**Addendum No. 1**

RE: Contract # C204684

**Haywood County (B-3186, B-5898)**

BRIDGES #155 AND 158 OVER RICHLAND CREEK ON US-23/74 AND  
BRIDGE #168 OVER US-19 AND US-23 ON US-23/74.

RICHLAND CREEK

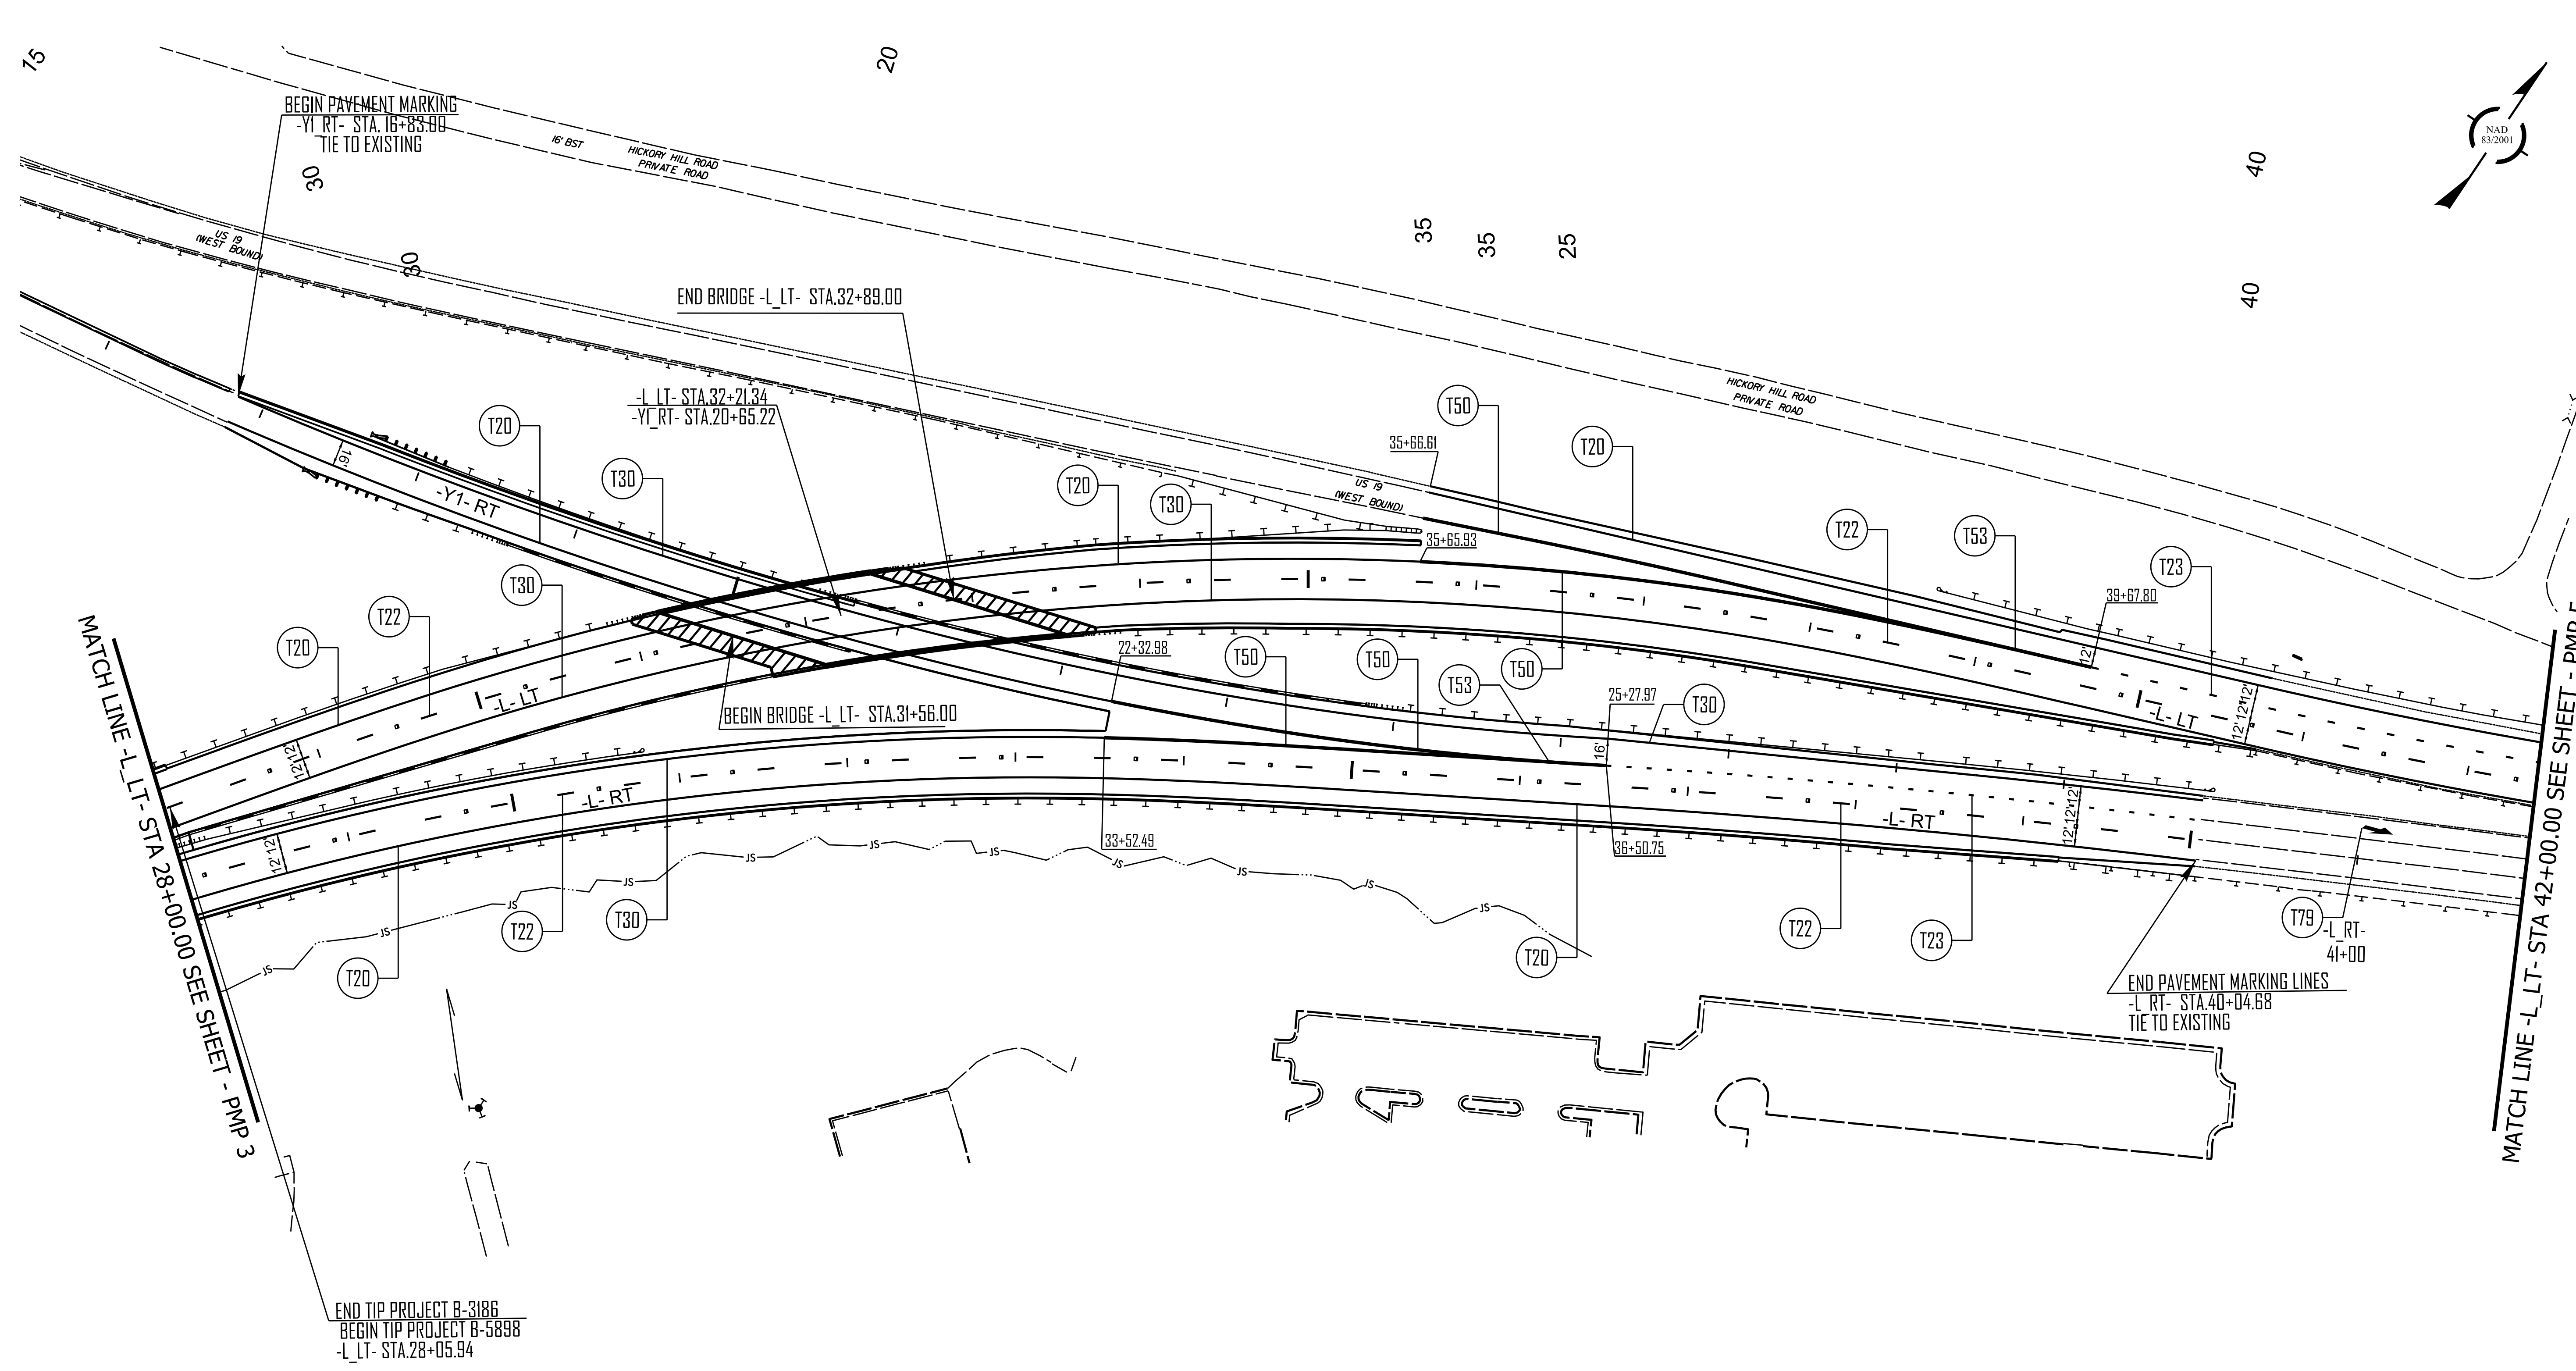
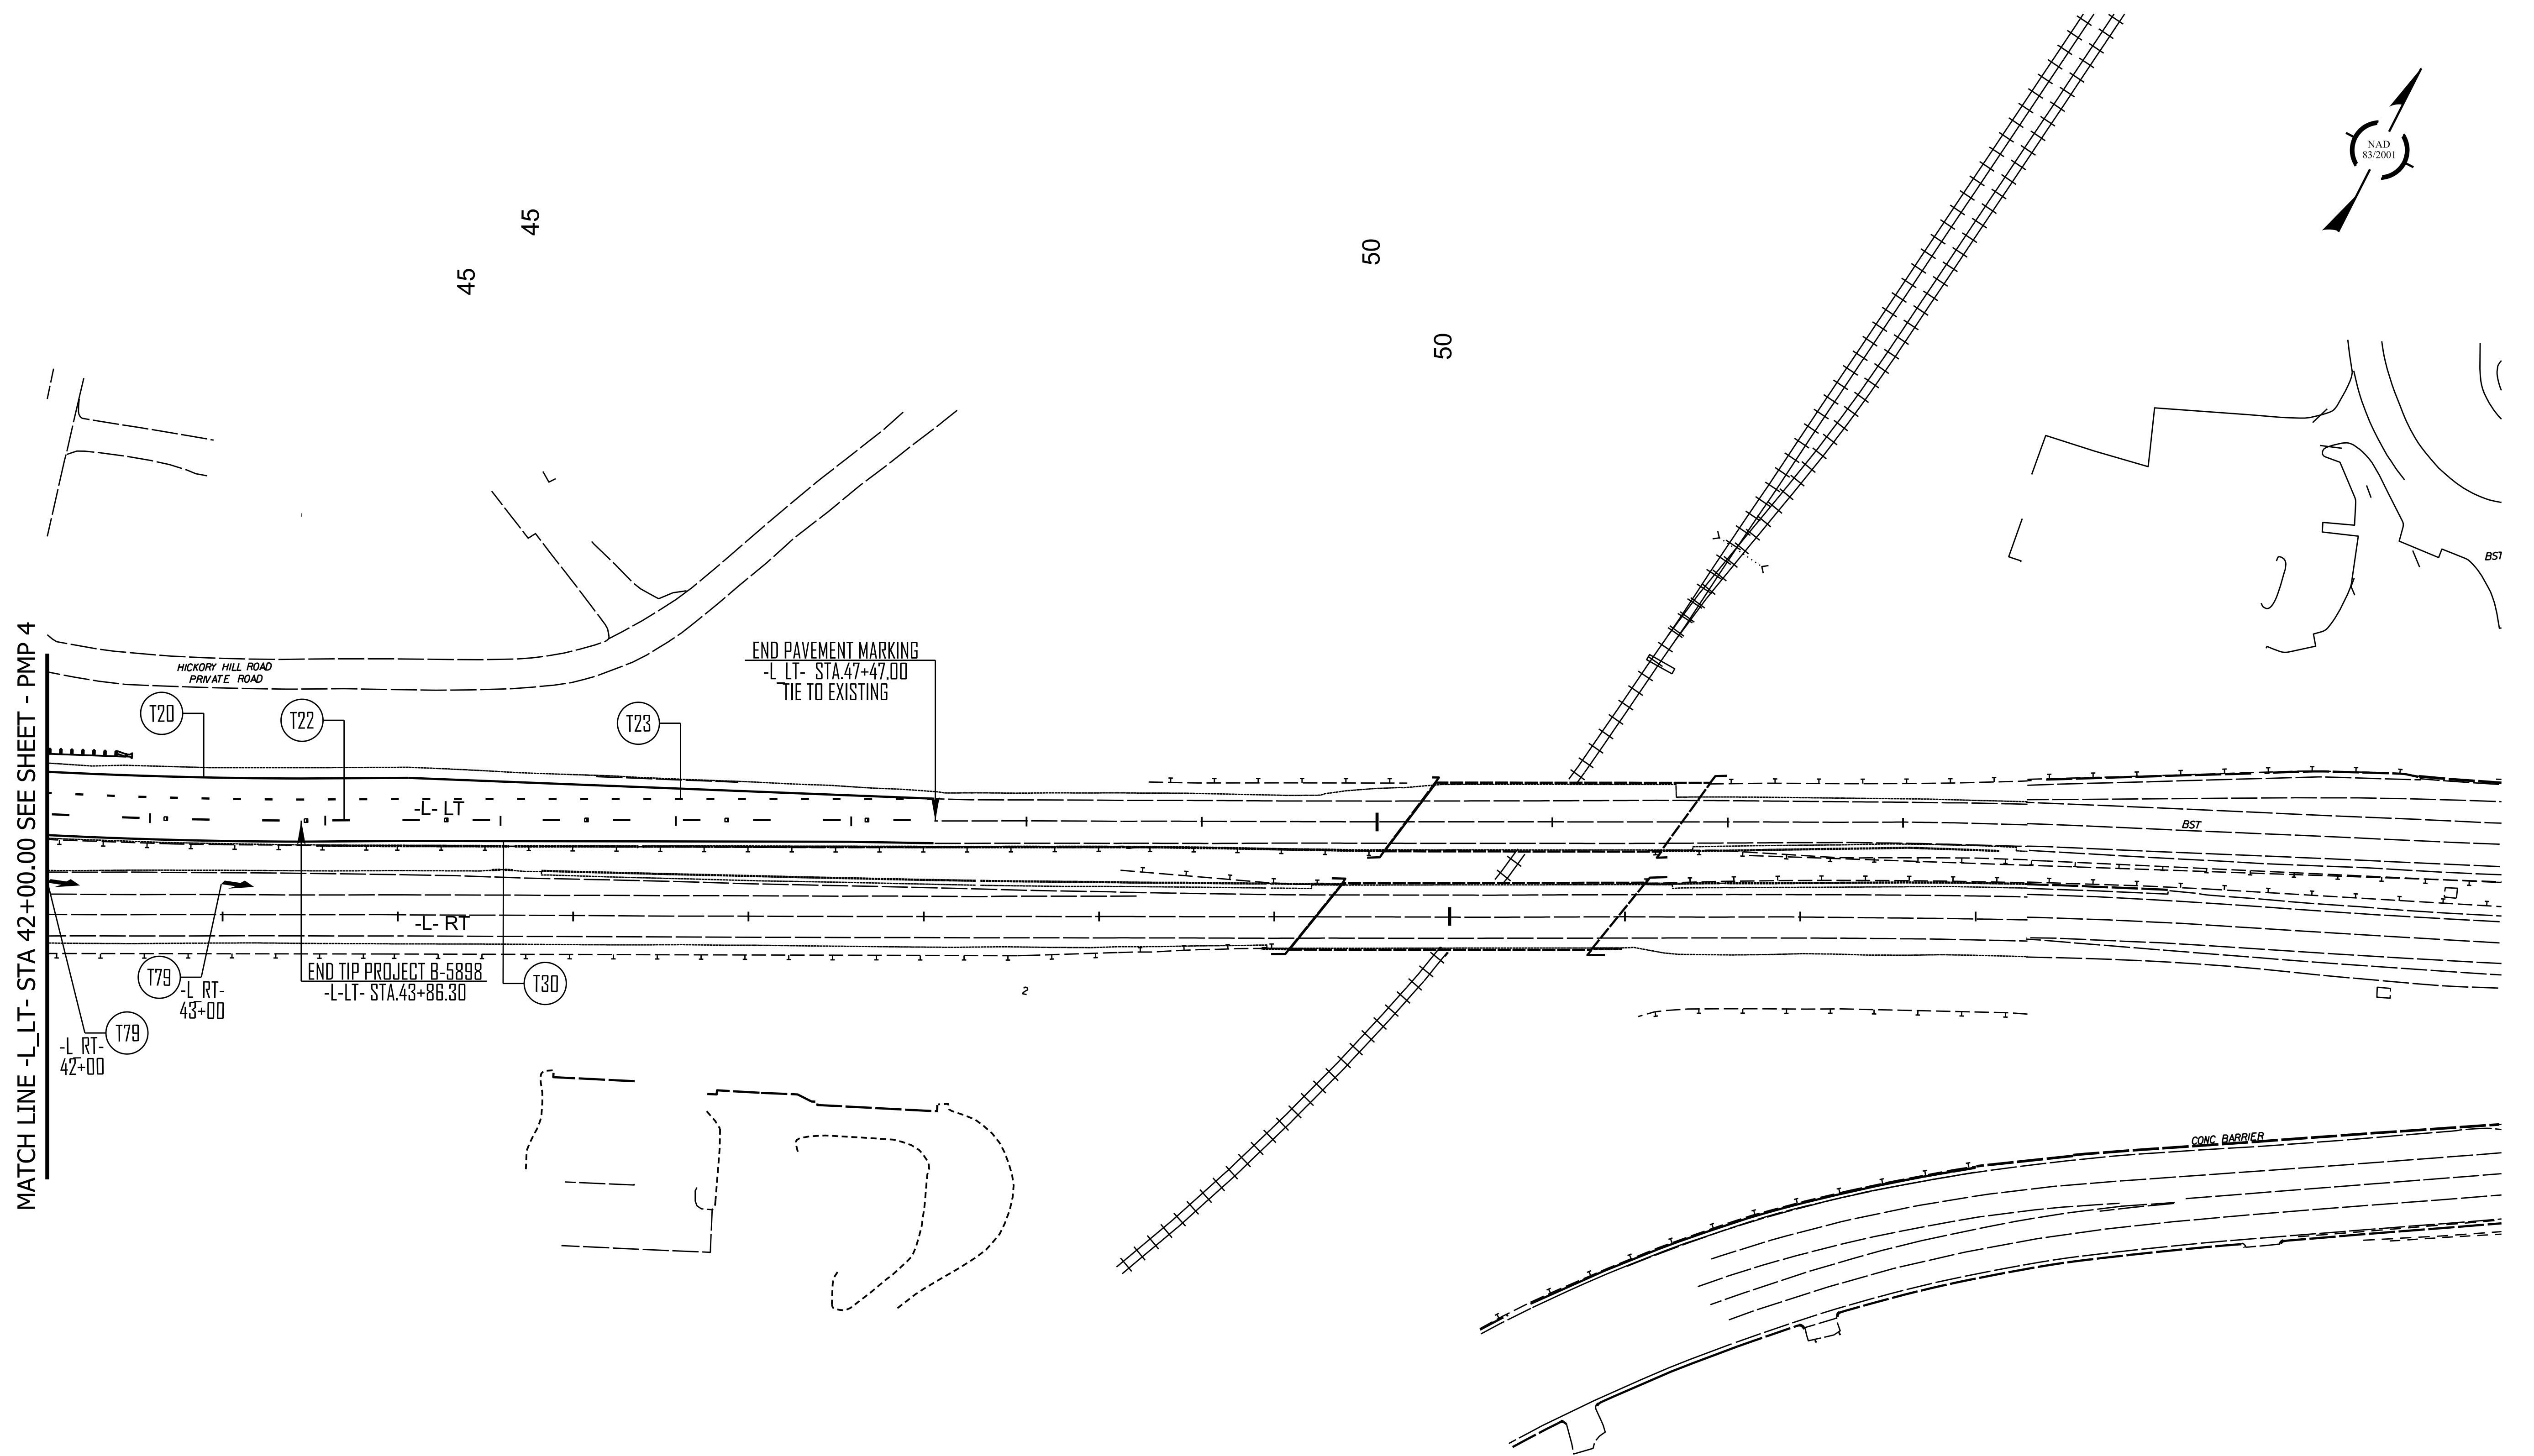
Sheet No.	Revision
PMP-1 thru PMP-5	Final Pavement Marking Schedule revised.
PMP-4 thru PMP-5	Merge arrows added, gore area striping revised.

**OVERHEAD SIGN ASSEMBLY "A"**  
 STA -L LT- 40+60  
 115' EAST OF EXISTING ASSEMBLY

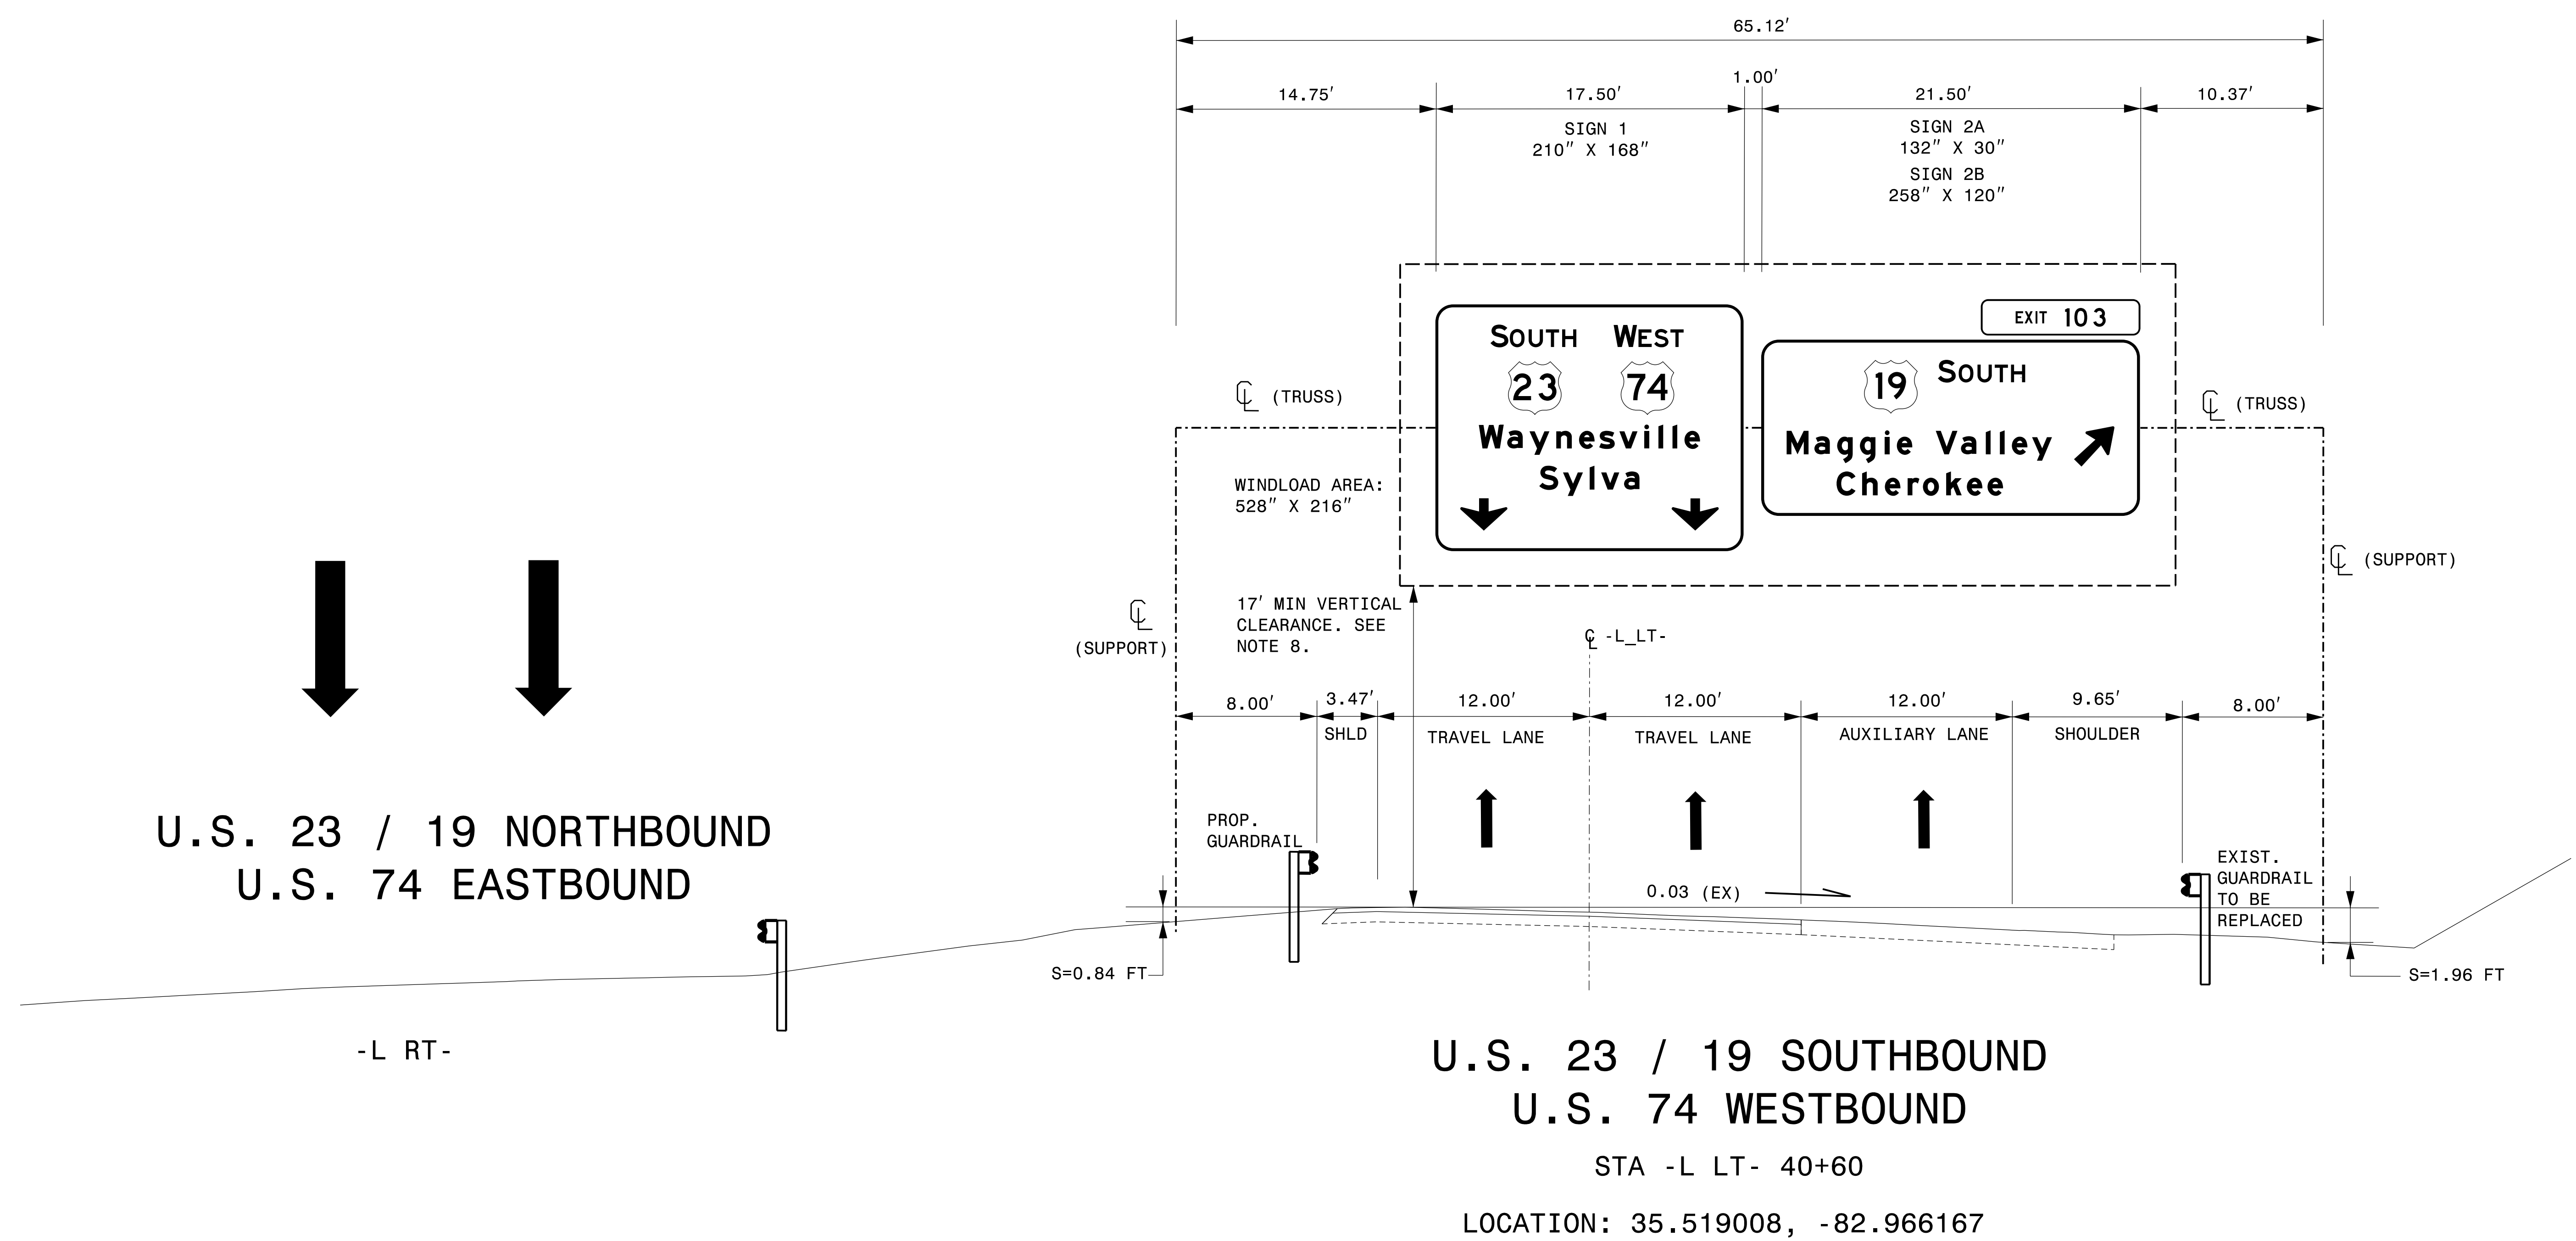
Sheet No.	Revision
SIGN-1	Quantities revised, removal of plan submittal block, and Roadway Standard Drawing list updated.
SIGN-2	Overhead Sign Assembly dimensions revised.
SIGN-2A	Existing Sign identifier numbers added, sizes revised.
SIGN-3 thru SIGN-5	Font, symbol, and panel sizes revised in sign designs. Milemarker signs clarified. Some signs modified to freeway sign size standards.
SIGN-6 thru SIGN-9	Added route labels and cardinal directions to roadways, revised project notes, and corrected sign number labels.
